Access Compliance Report Public Rights-of-Way (Curb Ramps)

Main Street: WINDMILL_AVE Cross Street: MERCANTILE_WAY Location: NW

ADA ID: RPRK211029115156 Ramp Type: Type 4 - Parallel Initial Pass/Fail: Fail Overall Compliance: No Severity Score: 32

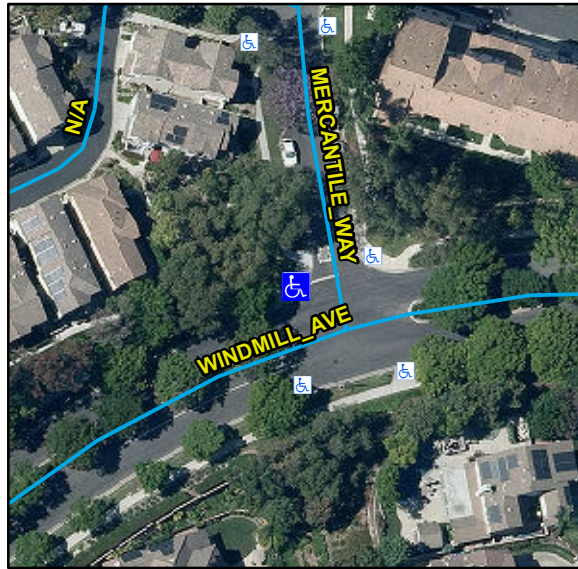
R204.3, R304.5.3, R304.3.2, STD 1115

Remove & Replace Curb Ramp With Two New Directional Ramps or Equivalent.
